**SUBJECT: ERRATA – WESTINGHOUSE ELECTRIC COMPANY – NUCLEAR
REGULATORY COMMISSION INTEGRATED INSPECTION REPORT NUMBER
70-1151/2018-004 AND NOTICE OF VIOLATION**

Report No.: 70-1151/2018-004

Facility: Columbia Fuel Fabrication Facility

Cross-sectional View of HF Spiking Station

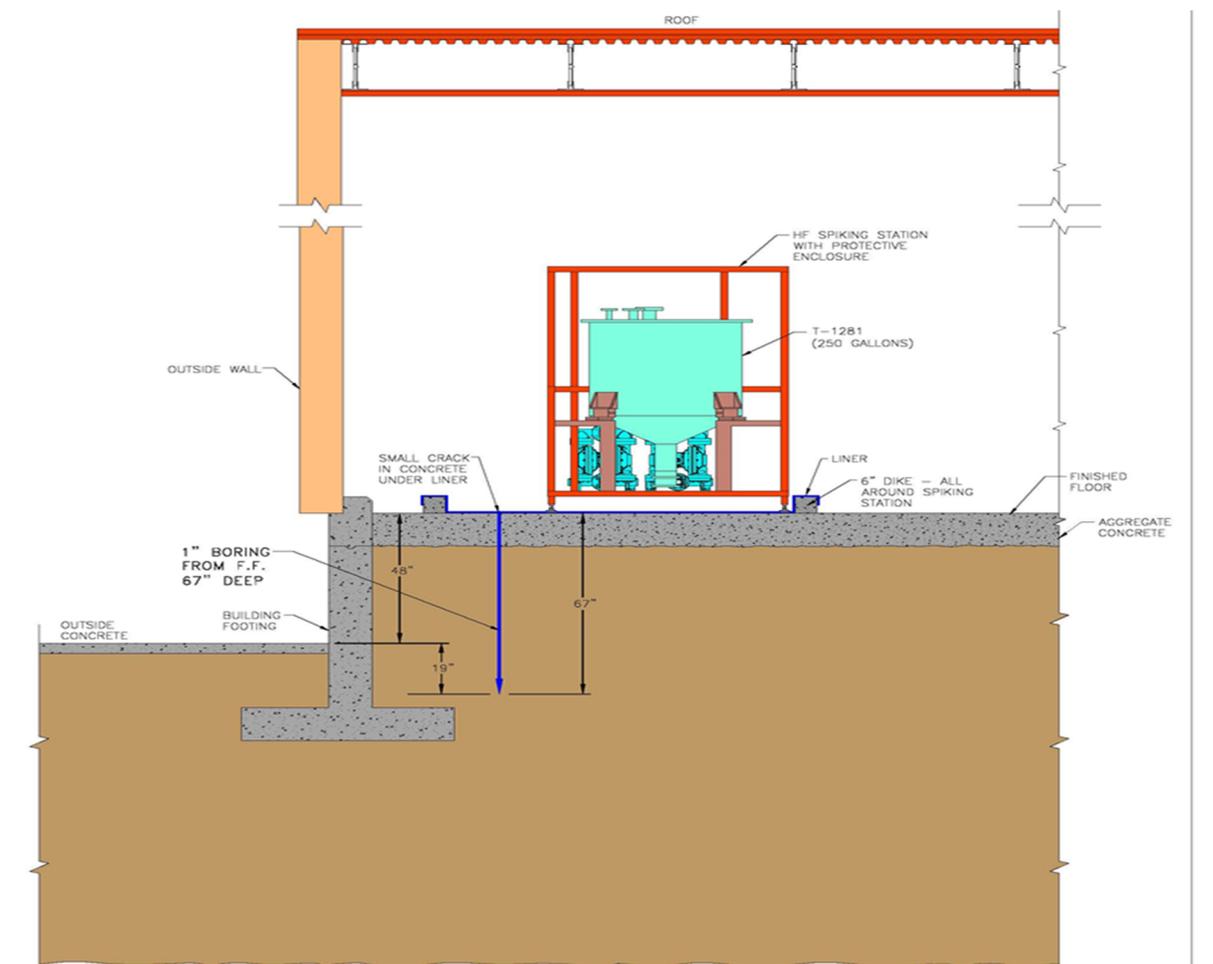
Description: On June 16, 2018, approximately 30 gallons of UNH solution leaked into the diked area surrounding the HF spiking station. A flanged piping connection was the source of the leaking solution. After the system was shutdown, a worker identified a small amount of solution that appeared to have migrated to the outside of the dike wall. CAP 2018-11205 was written to track the issue and Spiking Station #2 was shut down. The dike liner was removed as part of corrective measures. While the polypropylene liner was removed for repair work, a small crack was noticed in the epoxy floor covering. The plan was to repair the crack but as the loose epoxy was chipped away, a hole of approximately 3 inch diameter was revealed.

- IROFS ADUHFS-502, “Structural integrity of system components,” was the control in place which credits the structural integrity of the piping and equipment in the HF Spiking Station system which prevents liquids from being spilled.
- ADUHFS-902, “Dike walls surrounding HF Spiking Station 1 and 2,” was credited to reduce the spill size, thus mitigating the airborne release hazard to workers.

ADUHFS-502 had management measures applied in the form annual inspections of the piping structural integrity in accordance with OM81217. These annual inspections consist of visual inspections of all connection points for possible leaks, corroded flanges, corroded bolting and supports. The HF Spiking Station did not have an operating maintenance/preventative maintenance (OM/PM) established for the type of couplings that leaked on the HF Spiking Station even though it was recommended by the manufacturer.

ADUHFS-902 had management measures applied in the form of annual inspections of the liner in accordance with OM 81215, “SI-Safety, HF Spiking Station Pad Liner.” These inspections check the dike liner for evidence of tears, penetrations, or seam separation. The inspectors reviewed the three previous year’s inspection results and noted that the inspections failed to identify the degraded condition of the liner. A review of the liner following the event indicated a penetration through the liner which allowed UNH to migrate to between the liner and the concrete floor. In addition, the inspectors noted that portions of the liner had been previously repaired with numerous patches,

indicating that damage to the liner had occurred in the past. The inspectors noted that the annual inspection provides repair instructions, however, testing of the liner is not conducted following repairs.

ADUHFS-902 was considered degraded as indicated by cracks and degradation of the concrete dike wall. The inspectors noted that here was no policy or procedure in place to periodically inspect the area below the liner for indications of degradation of the concrete floor due to liner leaks.

- OM81215 was updated to 1) clarify the steps needed to perform the liner leak check, 2) require notification to Environmental Health and Safety (EH&S) of any degradation, and 3) change the frequency of the inspection from annual to quarterly and following any repair.
- The Spiking Station was barricaded and posted with instructions to put down walking pads prior to stepping on the liner to prevent liner damage.
- Hourly inspections of the liner have been commenced while the spiking station is in operation.

- Develop and implement an improved design for the spiking station system and dike area including a design review to prevent UNH solution from impacting the environment.
- Assess similar design configurations of a liner/environmental barrier relied on for secondary containment for proper post-maintenance and time-based PMs.
- Conduct an extent of condition for similar couplings used throughout the facility to verify PMs have been established.
- Additional long term corrective actions are detailed in ACA 2018-12123.
